TOWN OF JACKSON PLANNING & BUILDING DEPARTMENT

TRANSMITTAL MEMO

<p>Date: January 30, 2024</p> <p>Item #: P23-204, P23-206 & P24-007</p> <hr/> <p>Planner: Tyler Valentine</p> <p>Phone: 733-0440 ext. 1305</p> <p>Email: tvalentine@jacksonwy.gov</p> <hr/> <p>Owner & Applicant: Presbyterian Church of Jackson Hole PO Box 7530 Jackson, WY 83002</p>	<p style="text-align: center;">REQUESTS:</p> <p>The applicant is submitting a request for a Planned Unit Development (PUD) Amendment, Development Plan, and Conditional Use Permit for 21 deed restricted workforce units located on Parcel 1 – (PT. NE1/4NW1/4 SEC. 6, TWP. 40, RNG. 116 PARCEL 1)</p> <p>PIDNs: 22-41-16-31-4-14-114</p> <p>For questions, please call Tyler Valentine at 733-0440 x 1305 or email the address shown to the left. Thank you.</p>
---	---

RE: P23-204 and P23-206 Presbyterian Church of Jackson Hole Workforce Housing Development

SHEET
C2.2

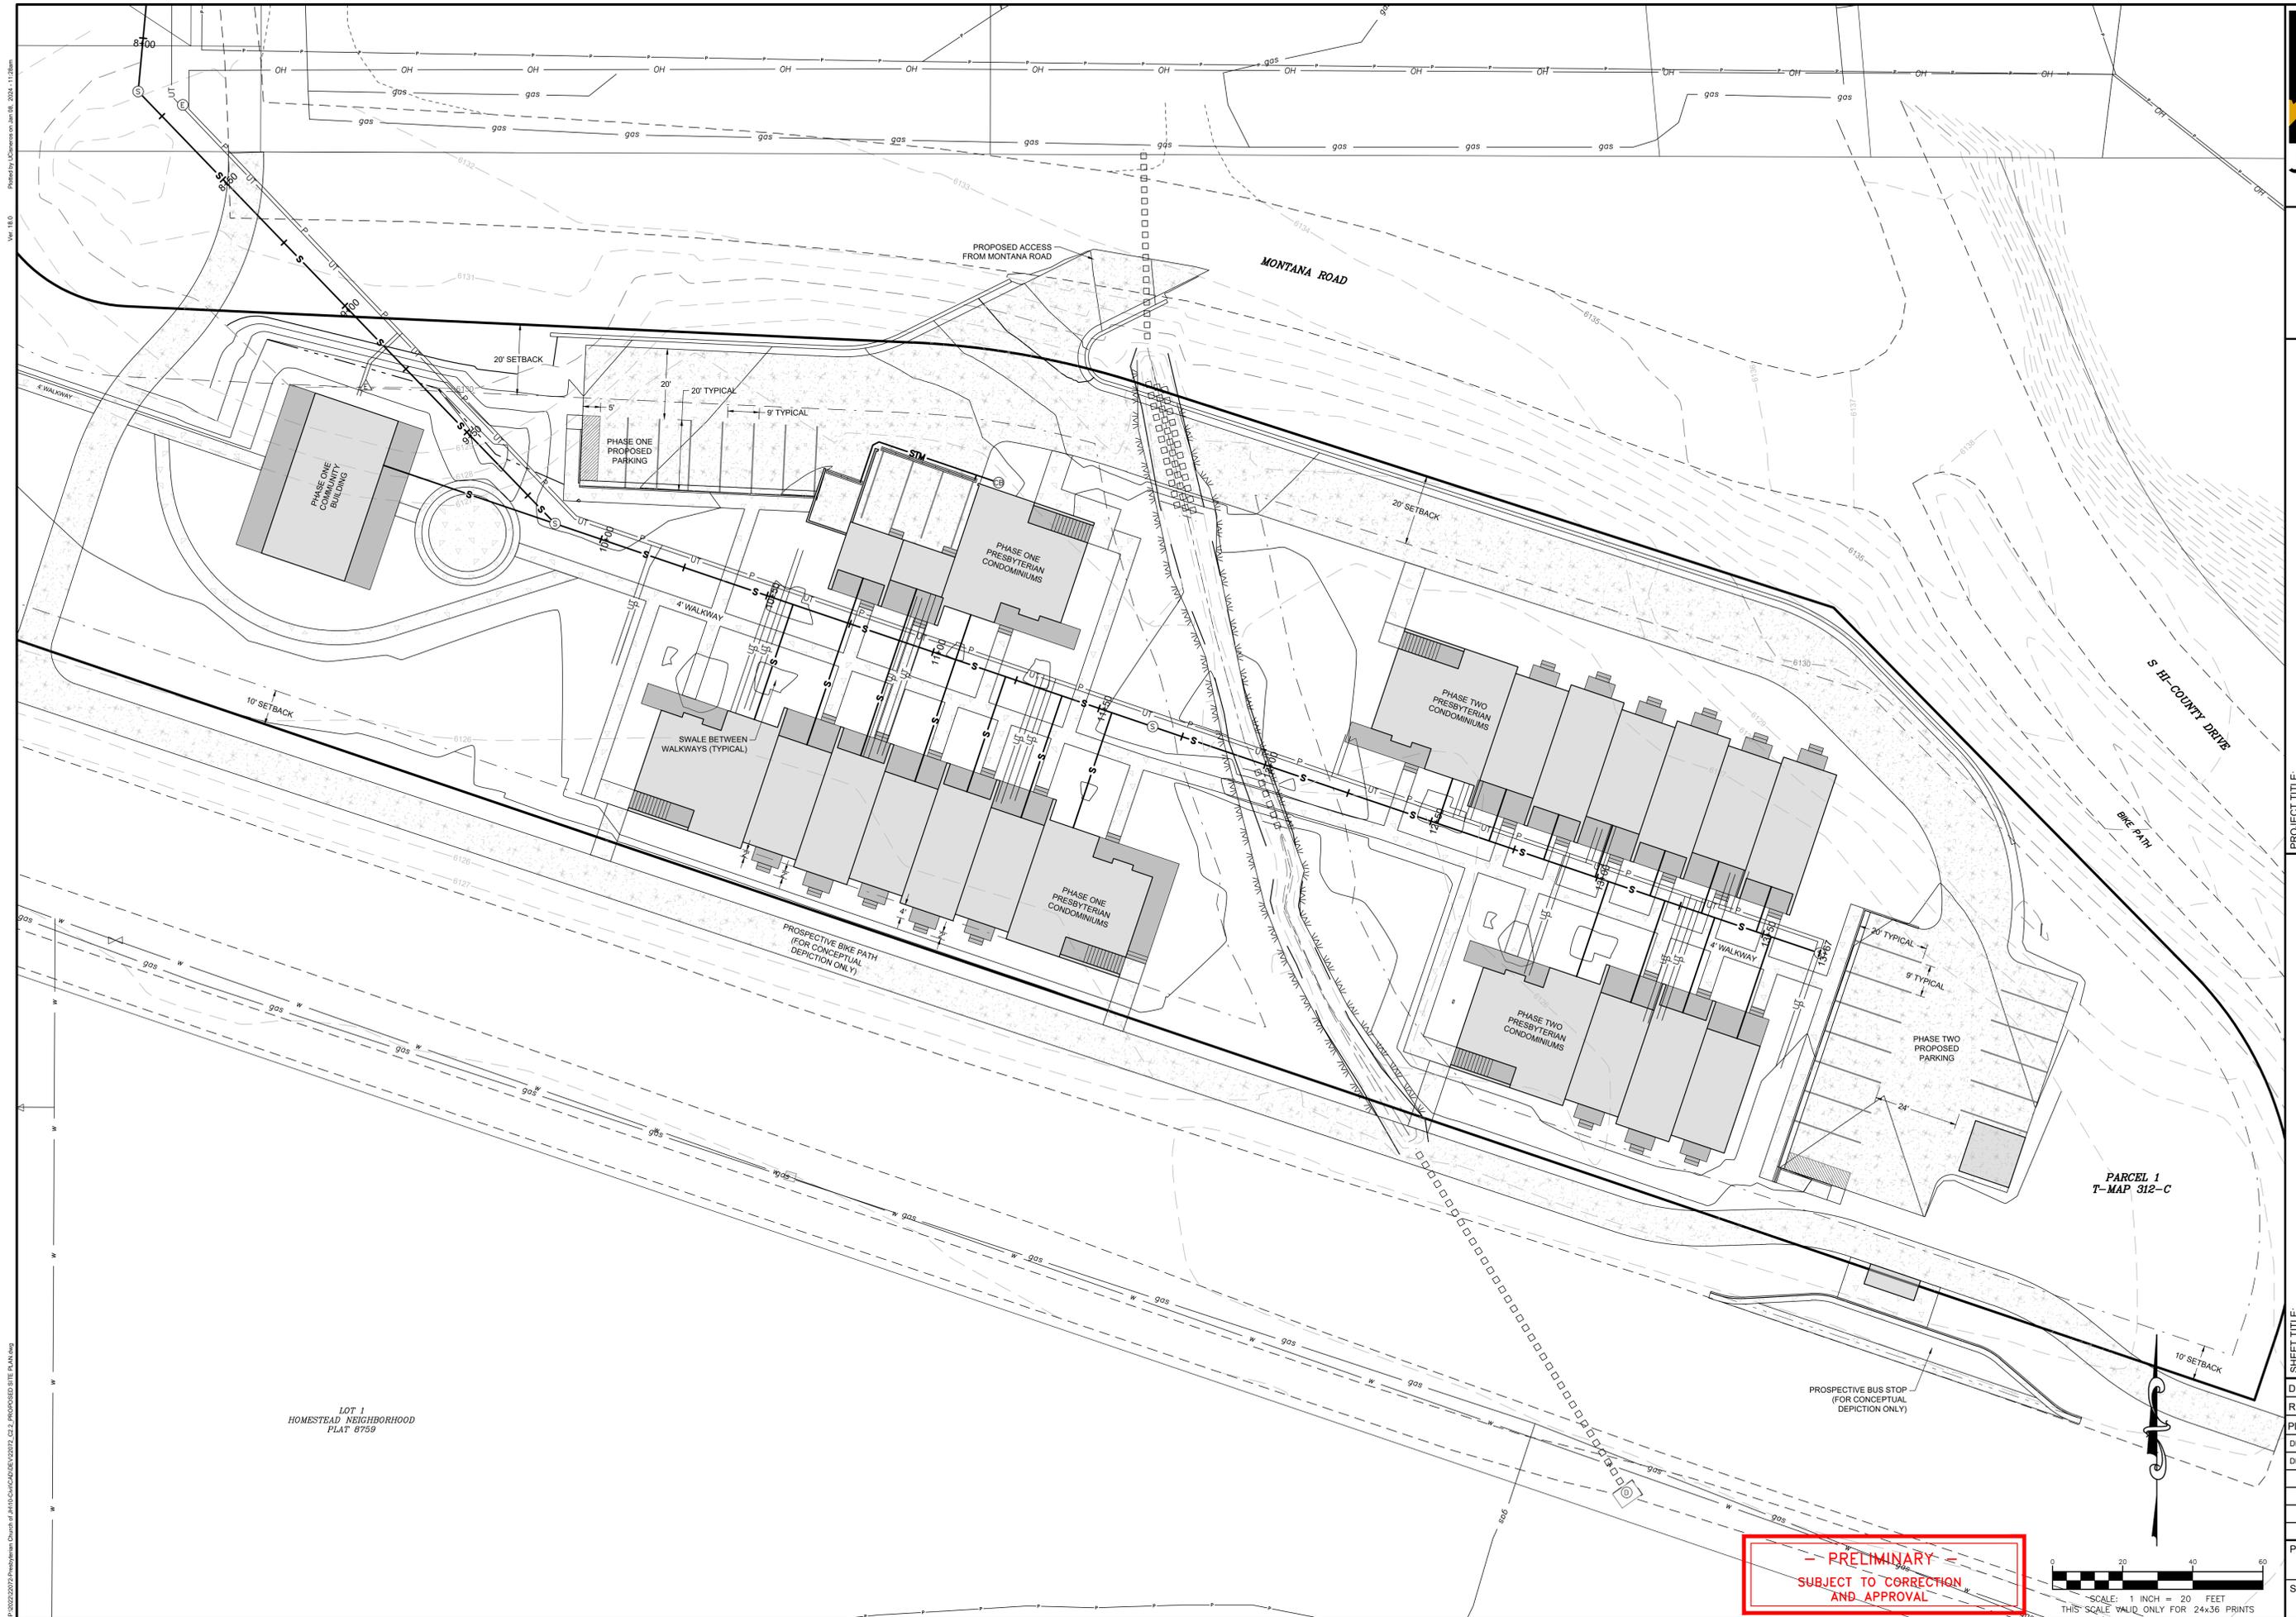
3. ***Please provide dimensions for all drive aisles, parking spaces, back-out distances, etc. Also, both South Park Loop Rd and Montana Rd are considered primary streets which require a 20’ building setback for primary structures and 30’ for accessory structures. Please show this change in the application and on the site plans.***

See revised site plan included with this letter.
